ADDENDUM NO: 01

PROJECT: Center Grove MS Central Renovation

PROJECT NO: 2024017 DATE: June 25, 2025 BY: Jack Leibham

DRAWING NUMBER
S201

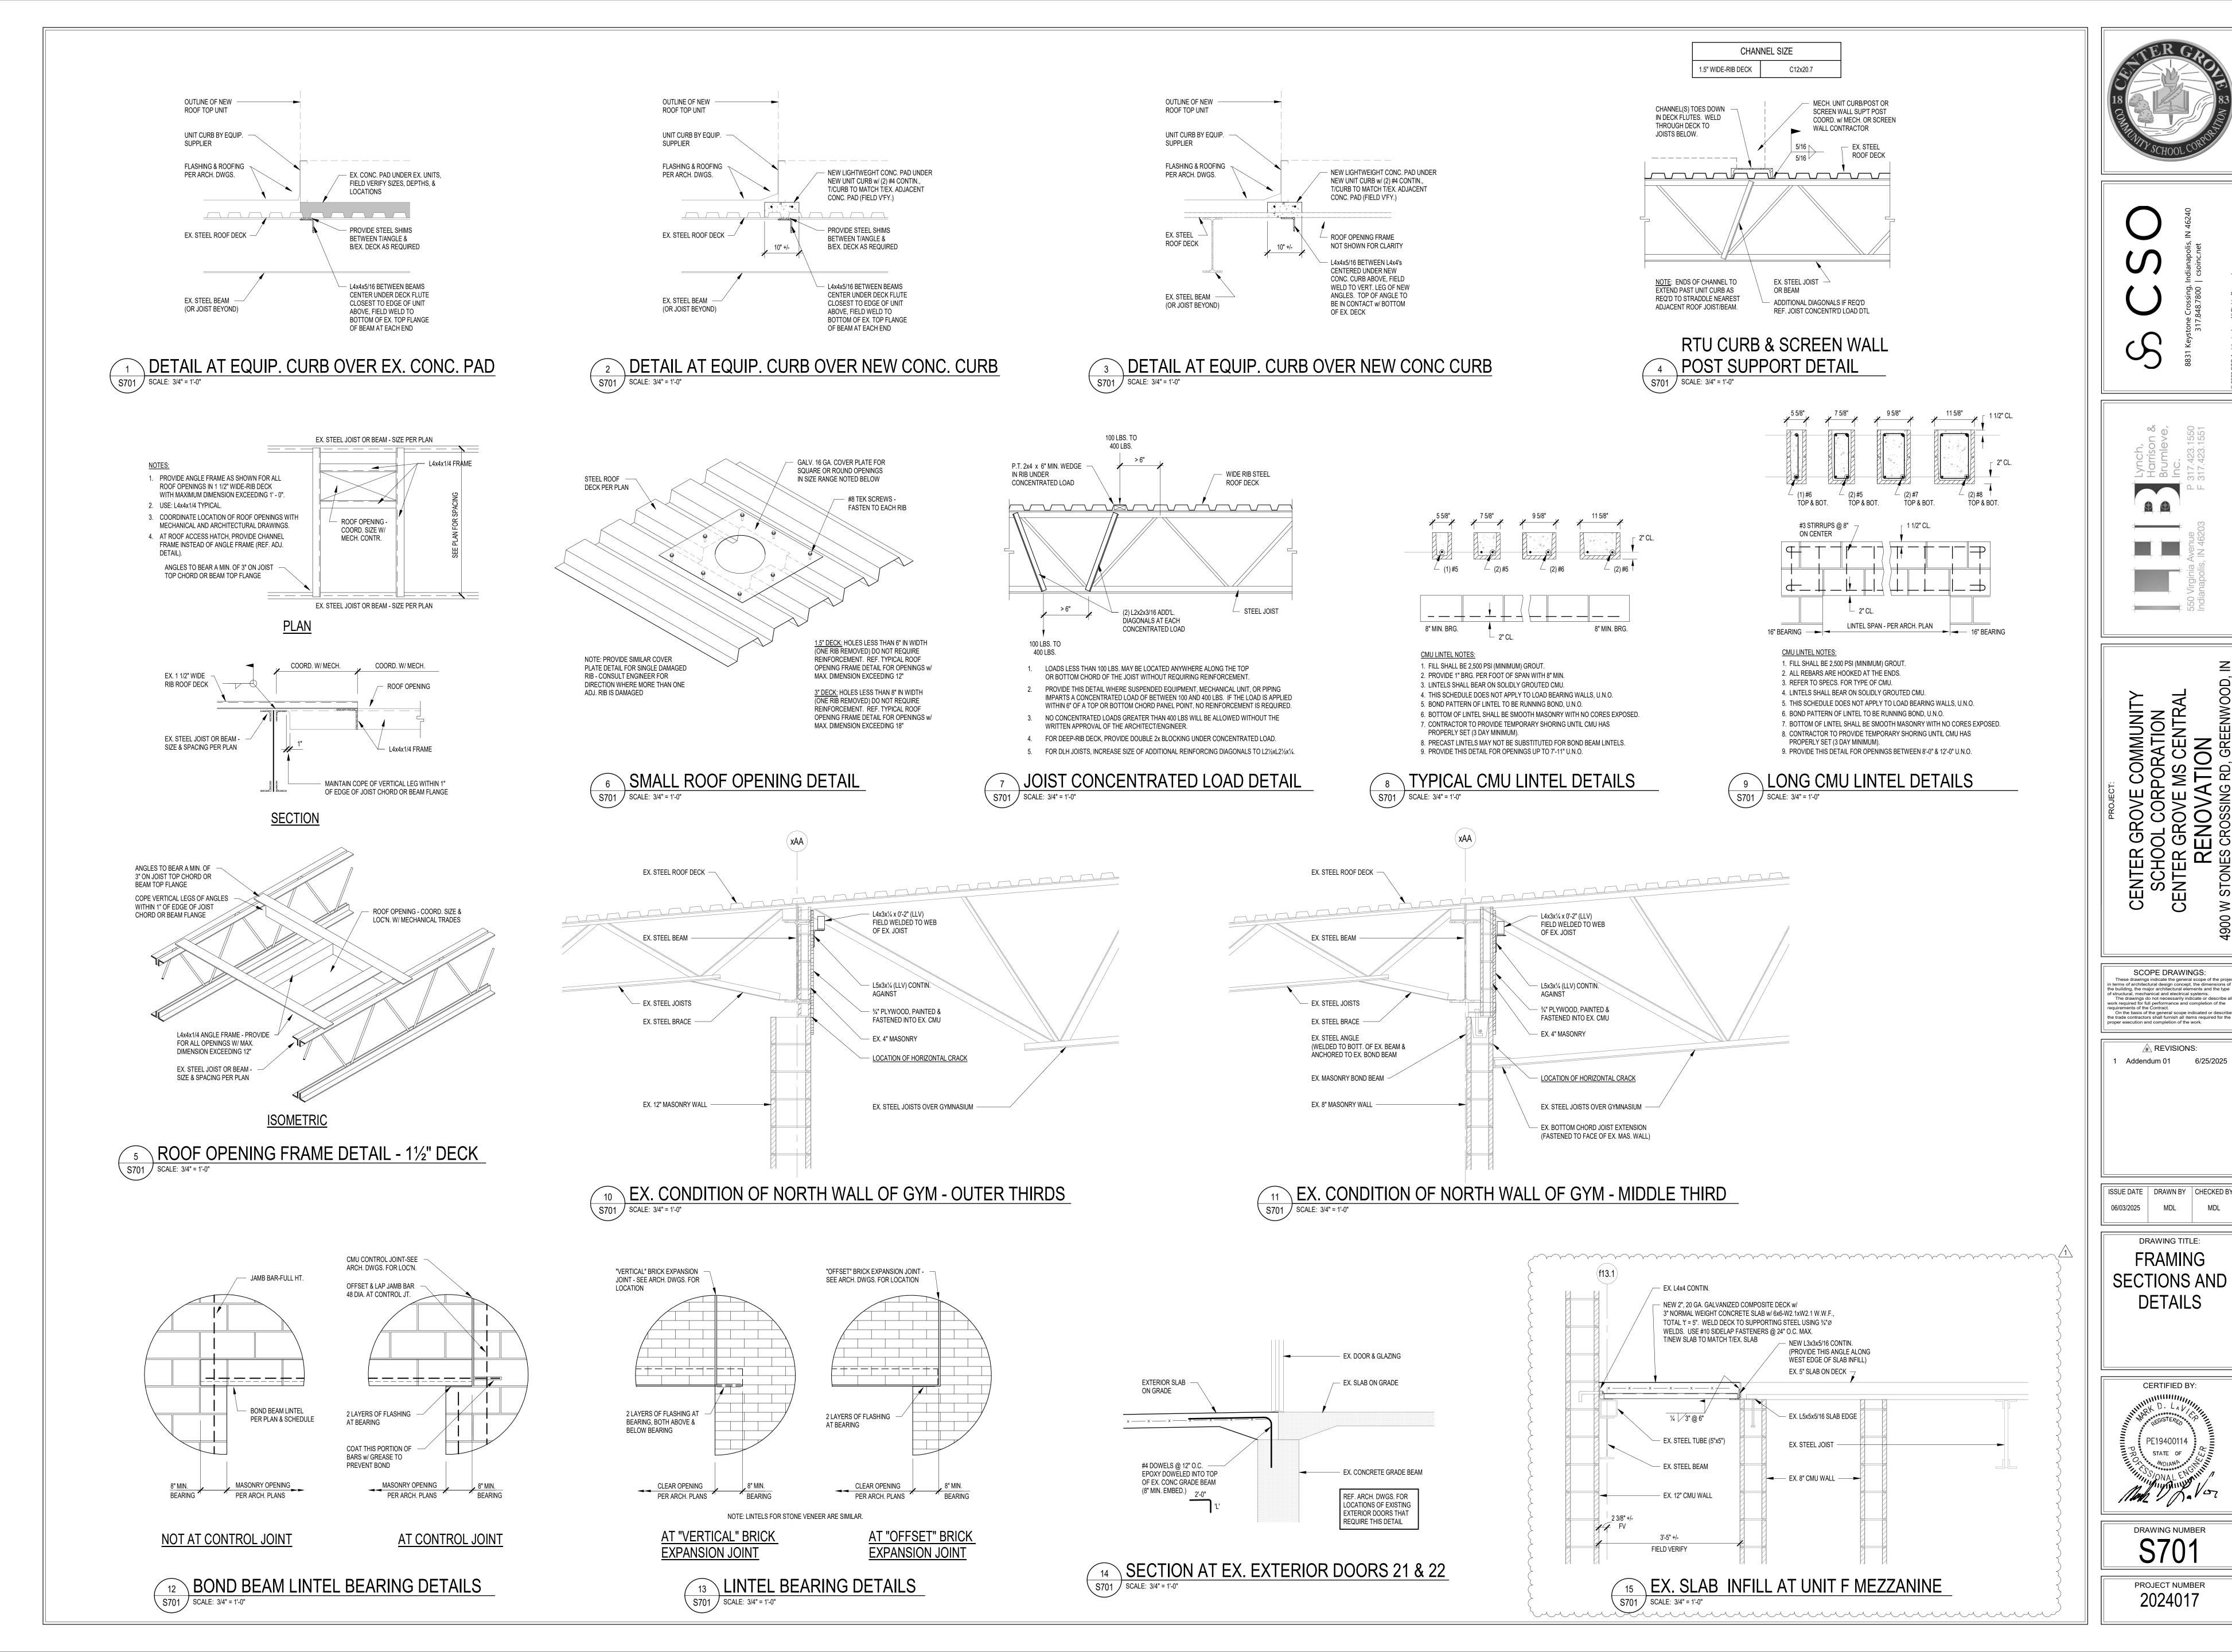
- 3.1 <u>S201 ROOF TOP UNIT SUPPORT FRAMING</u>
 - A. The "Mezzanine Floor Framing Plan Unit F", 6/S201 shall be added to this sheet as shown on the attached drawing.
- 3.2 <u>S701 FRAMING SECTIONS AND DETAILS</u>
 - A. "Ex. Slab Infill at Unit F Mezzanine", Section 16/S701, shall be added to this sheet as shown on the attached drawing.
